PACKARD MOTOR CAR COMPANY  
DETROIT·MICHIGAN

May 14, 1923

BRAKE SQUEAKS

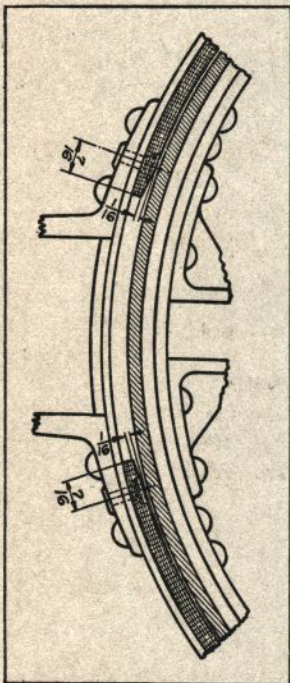
The procedure now in effect in the Factory has been found successful in correcting foot brake squeak on Single-Six cars, and may be followed in the field to take care of cars now in service.

The foot brake bands should be removed and the lining at the rear reworked, as shown in the illustration. The rear ends of the lining should project not more than 7-16" beyond the center line of the rivets and the lining should be pounded down at the end in the manner illustrated, so that when the brake is applied and the lining makes contact with the drum, there will be no sharp edge bearing against the drum.

The success or failure of this procedure rests entirely in the manner of treating the lining at this point, and if the illustration is carefully followed, no trouble will be experienced. The change took effect in the Factory in the neighborhood of motor number 29200.
